UNITED STATES ENVIRONMENTAL PROTECTION AGENCY  
REGION III  
1650 Arch Street  
Philadelphia, Pennsylvania 19103-2029

RE: EPA's Hydrogeological Evaluation  
Saegertown Superfund Site

The purpose of this letter is to assist you with the preparation of the revised 2001 Annual Report by providing a brief summary of EPA's hydrogeological evaluation of groundwater flow in the immediate vicinity of the Saegertown Site ("Site").

**USEPA INTERPRETATION OF GROUNDWATER POTENTIOMETRIC SURFACE  
MAP, DEEP WELLS, SEPTEMBER 2001  
(SUMMER SAMPLING)**

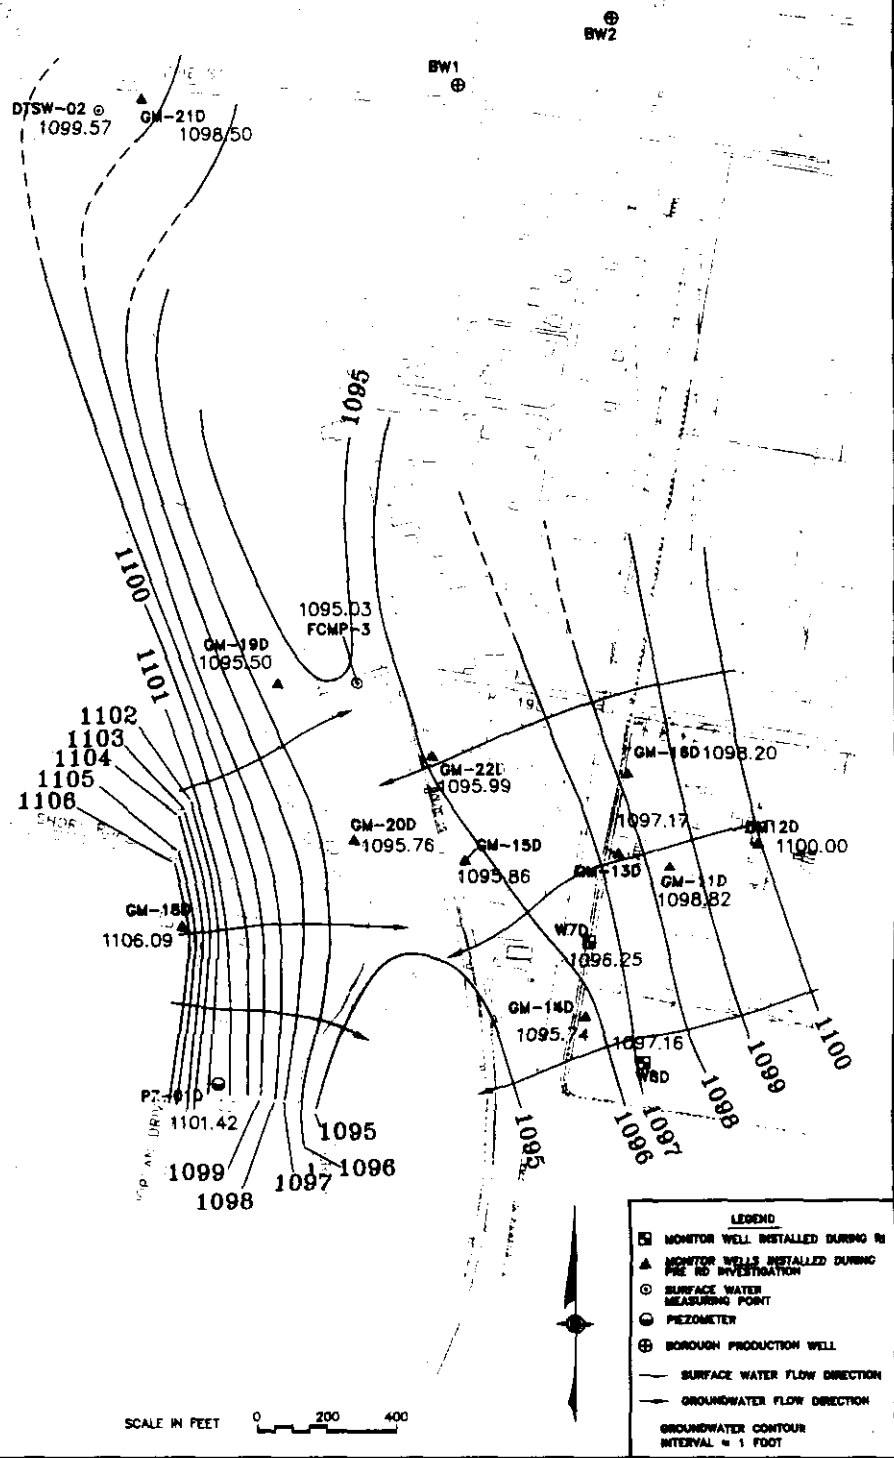
Monitoring well nest GM-15S and GM-15D are located near the eastern bank of French Creek and reveal a downward flow of groundwater. VOC contamination in monitoring well GM-15D is approximately 200 ppb, comprised primarily of cis-1,2 DCE and vinyl chloride. The same contaminants, cis-1,2 DCE and vinyl chloride are observed 300 feet away just shortly beyond the western bank of French Creek in monitoring well GM-20D, indicating that some contamination is migrating beneath French Creek. I agree that a significant portion of the migrating groundwater may be discharging into French Creek, however I disagree that the valley drainage area is limited by the current physical boundary of the Creek. Limited contamination is present in GM-20D because it is located in the relatively flat portion of the valley, the valley drainage area.

Residential wells located in or near the base of the valley may also be located in the valley drainage area and impacted by the contaminants in a manner similar to GM-20D. The same contaminants detected in monitoring wells GM-15D and GM-20D, vinyl chloride and cis-1,2 DCE, are routinely detected at low levels in residential well PW-7 (see Table 7, 2001 Annual Report). Residential well PW-7 is located in the immediate vicinity of GM-20D.

Re-contouring of the Potentiometric Surface Map for Deep Wells reveals a broad flat low area that includes GM-15D, GM-20D and PW-7, indicating the potential for interconnection. Groundwater flow within or adjacent to the valley drainage area may also be affected by preferential flow pathways resulting from subsurface paleochannels which may be intercepted by monitoring wells and/or residential wells. Additional complicating factors such as pumping or injection rates and the heterogeneity of the subsurface will also affect groundwater flow and the migration of contaminants.
